Project	IEEE 802.16 Broadband Wireless Access Working Group < http://ieee802.org/16 >	
Title	Comments on Synchronous MBS Transmission in MR Networks	
Date Submitted	2007-07-05	
Source(s)	Gang Shen, Kaibin Zhang, Wei Ni, Jimin Liu, Shan Jin Alcatel Shanghai Bell, Research & Innovation 388#, Ningqiao Road, Shanghai, P. R. C.	Voice: 86-21-50551240-8194 Fax: 86-21-50554554 Email: gang.a.shen@alcatel-sbell.com.cn
Re:	IEEE 802.16j-07/019, "Call for Technical Comments Regarding IEEE Project 802.16j."	
Abstract	This contribution proposes comments on synchronous MBS transmission method	
Purpose	Propose the text changes regarding MBS in multi-hop relay networks for QoS support	
Notice	<i>This document does not represent the agreed views of the IEEE 802.16 Working Group or any of its subgroups. It represents only the views of the participants listed in the "Source(s)" field above. It is offered as a basis for discussion. It is not binding on the contributor(s), who reserve(s) the right to add, amend or withdraw material contained herein.</i>

Comments on Synchronous MBS Transmission in MR Networks

Fig.1 Procedures of Synchronized MBS for Multi-hop Relaying

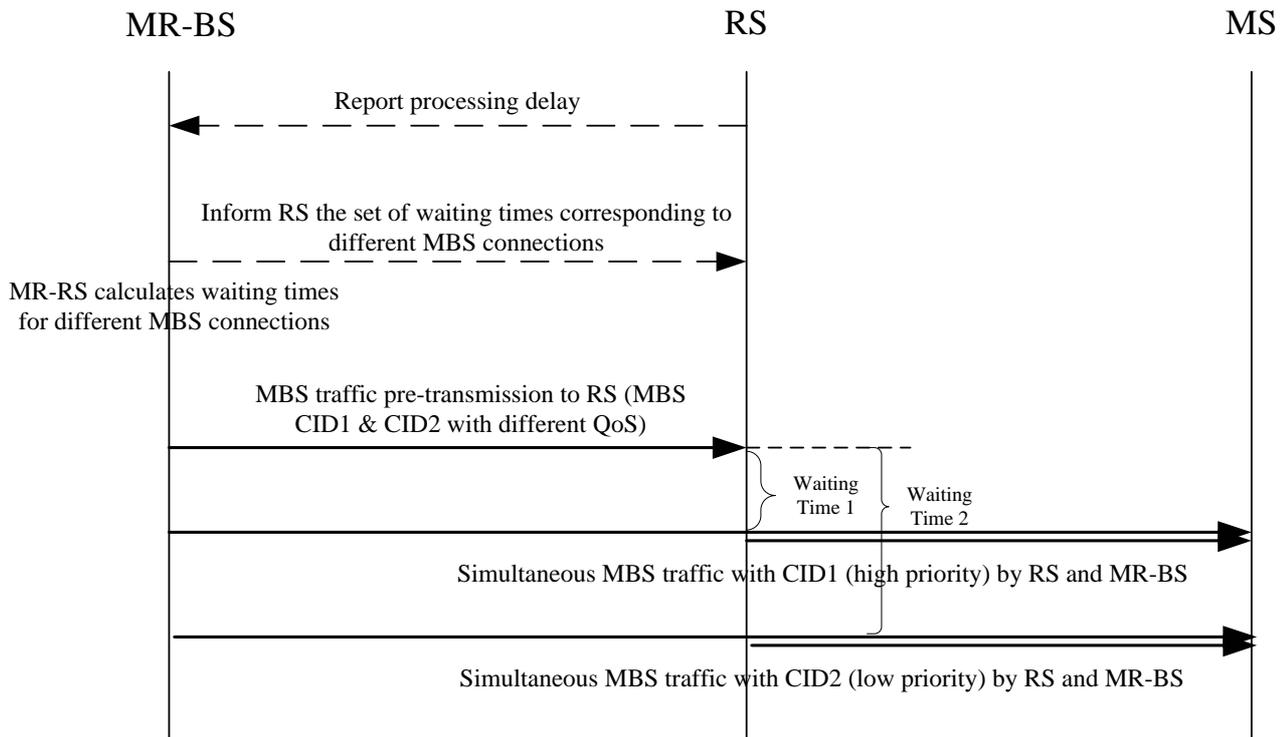
An example is illustrated in Fig. 1, there are two MBSs with CID1 and CID2, where the first one has higher QoS priority. In the case of limited bandwidth, MR-BS allocates resource for the MBS with CID1 firstly with short waiting time configured. In comparison, the MBS traffic with CID2 is configured with a longer waiting time in RS. RS may receive MBS data within one frame, however re-transmits different MBS data at different frames.
